HISTORIC AND DESIGN REVIEW COMMISSION

August 17, 2016

HDRC CASE NO: 2016-274
ADDRESS: 431 HAYS ST
LEGAL DESCRIPTION: NCB 528 BLK 1 LOT E 16.7 FT OF 15 & E 53.06 FT OF 16
ZONING: R5 H
CITY COUNCIL DIST.: 2
DISTRICT: Dignowity Hill Historic District
APPLICANT: David Hope
OWNER: David Hope
TYPE OF WORK: Construct new carport
REQUEST:

The applicant is requesting a Certificate of Appropriateness for approval to construct a 450 square foot carport with front gable and wooden posts to the rear of the property.

SOUTH FACE

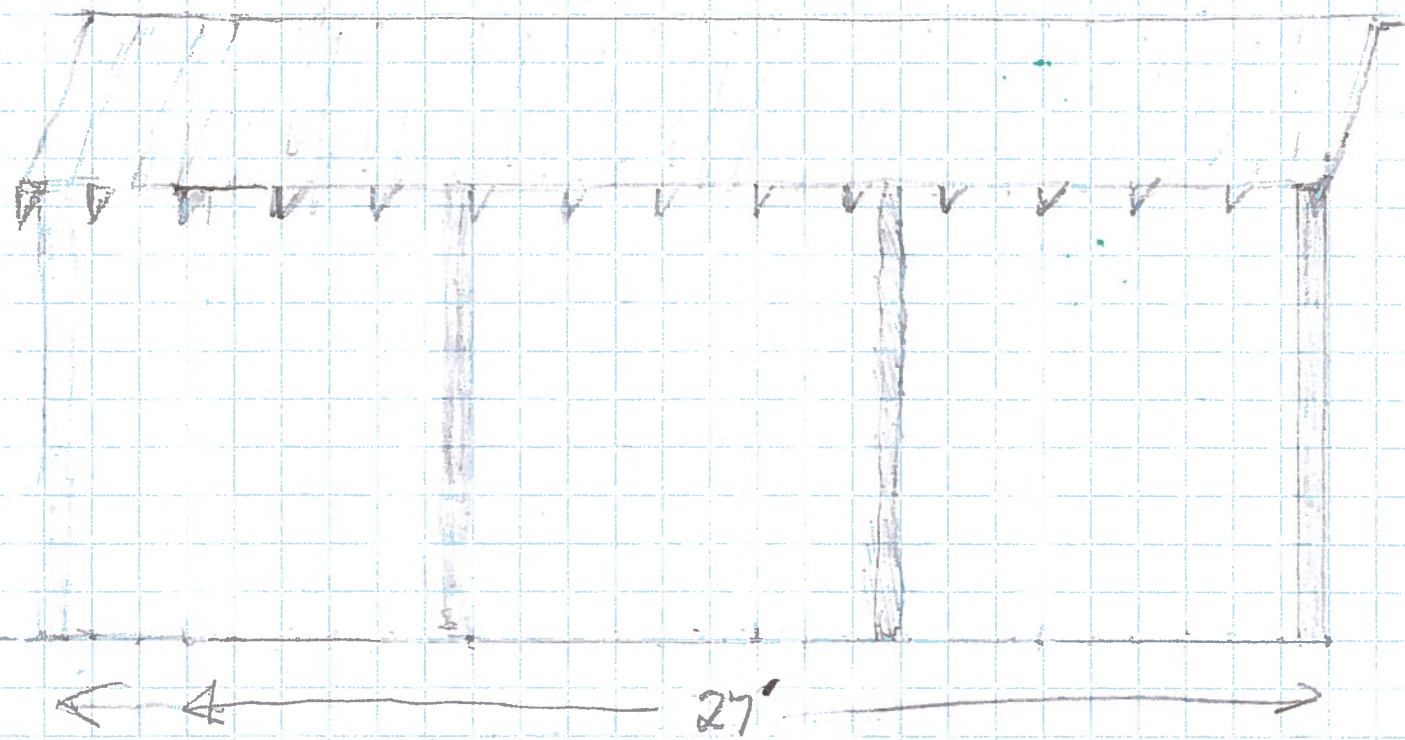
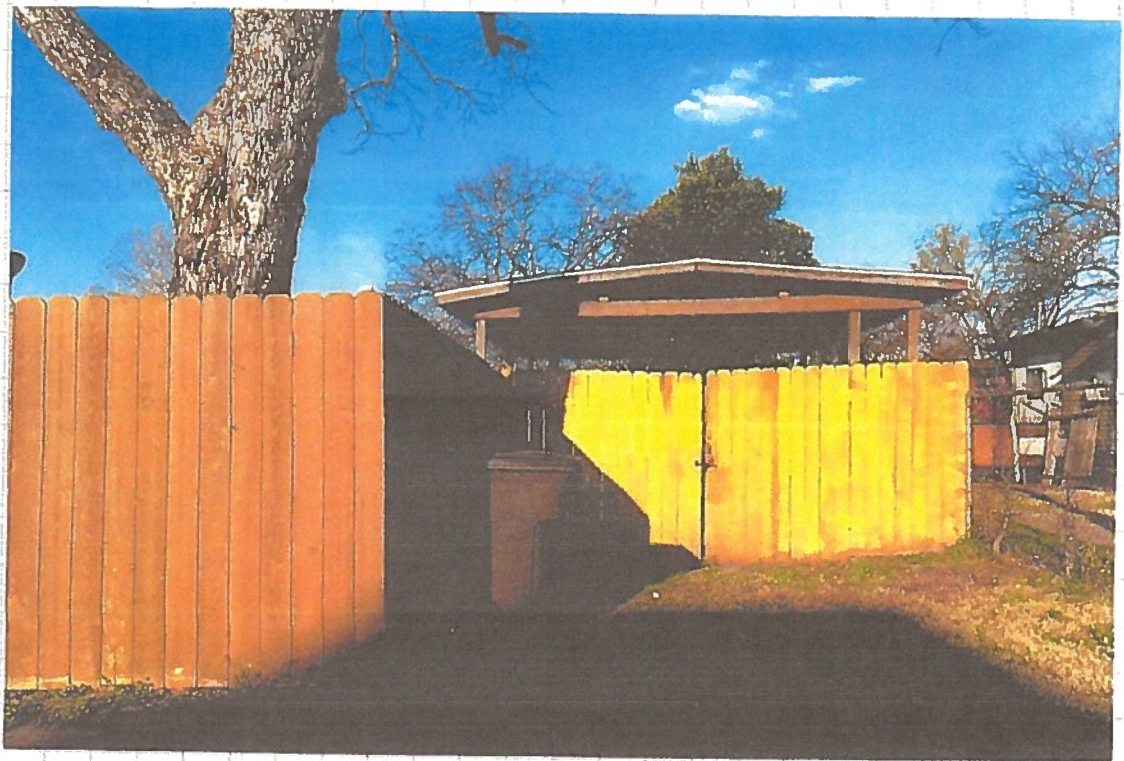
- c. SCALE/MASSING/FORM - The applicant is requesting to build a carport to the rear of the property with open gable facing the side street and a 13' in ridge height. According to the Guidelines for New Construction 5.A.i., new outbuildings should be visually subordinate to the principal historic structure in terms of their height, massing, and form. Staff finds the proposed carport appropriate and consistent with the Guidelines.

- d. MATERIALS –The applicant is proposing the carport with simple square wood columns and a standing seam metal roof to match the roof on the main structure. According to the Guidelines for New Construction 5.A.iii., new outbuildings should relate to the period of construction as the historic house through the use of complementary materials. The proposed materials are consistent with the Guidelines.

- e. CHARACTER – The main structure is a folk Victorian style home. The applicant is proposing a simple carport with wooden posts and a standing seam metal roof. According to the Guidelines for New Construction 4.A.ii., architectural details should be incorporated that are in keeping with the predominant architectural style. Staff finds character appropriate for a folk Victorian home. Staff finds the proposal is consistent with the Guidelines.

Staff recommends approval as submitted based on findings a through f.
